## Proposed Revisions to a Standard Plans Index

Index Number: 700-010 Sheet Number (s): 4 of 10

Index Title: Single Column Ground Signs

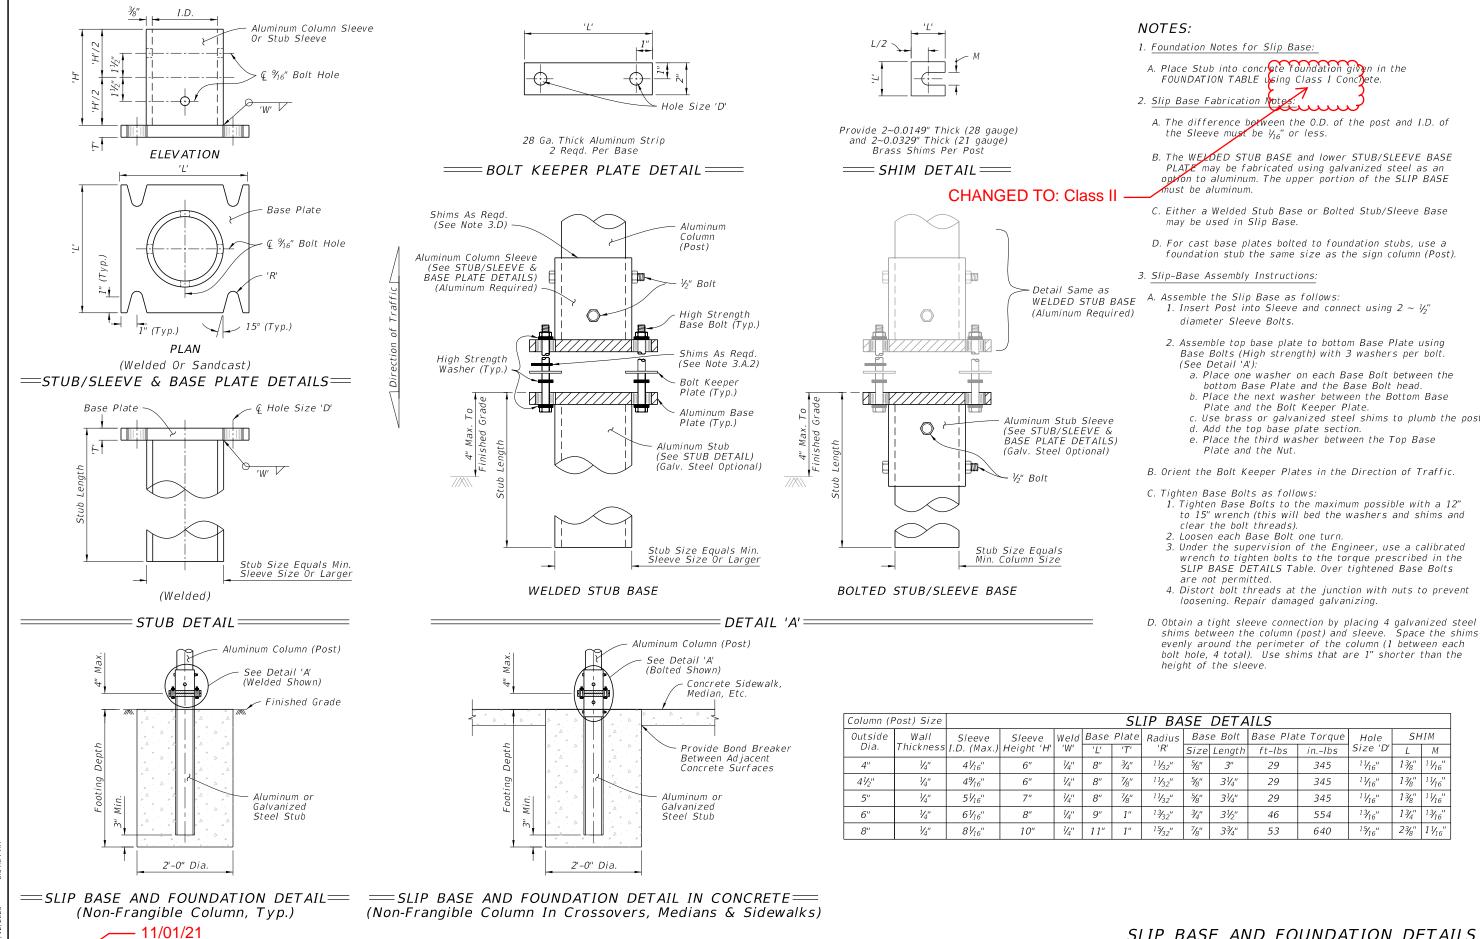
**346-2.3 Supplementary Cementitious Materials:** Supplementary cementitious materials are required to produce binary or ternary concrete mixes in all classes of concrete specified in Table 346-3, except for the following when used in slightly aggressive environments: Class I, Class I (Pavement), and Class II.

**346-3.1 General:** The classifications of concrete are designated as Class I. Class I (Pavement), Class II, Class II (Bridge Deck), Class III, Class III (Seal), Class IV, Class IV (Drilled Shaft), Class V, Class V (Special), Class VI, and Class VII. The 28-day specified minimum compressive strength, maximum water to cementitious materials ratio and target slump of each class are detailed in Table 346-3. The required air content for all classes of concrete is less than or equal to 6.0%.

SLIP BASE AND FOUNDATION DETAILS

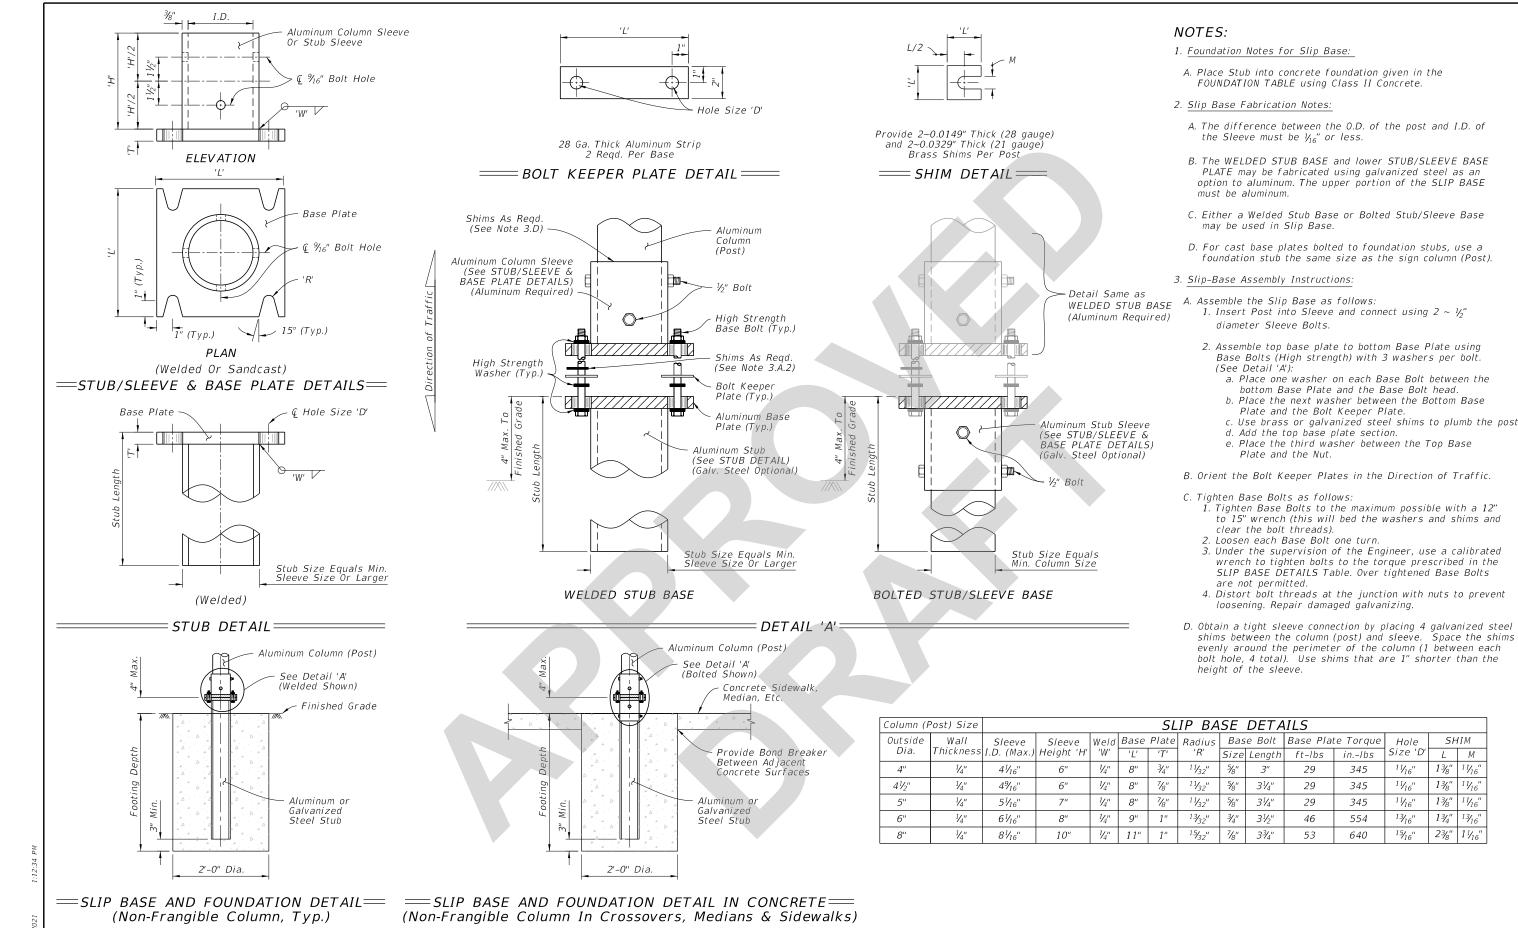
Sheet 4: Changed NOTE 1 from "Class I" to "Class II".

Changed to reflect Materials specification change that removes the designation for Class I Concrete.
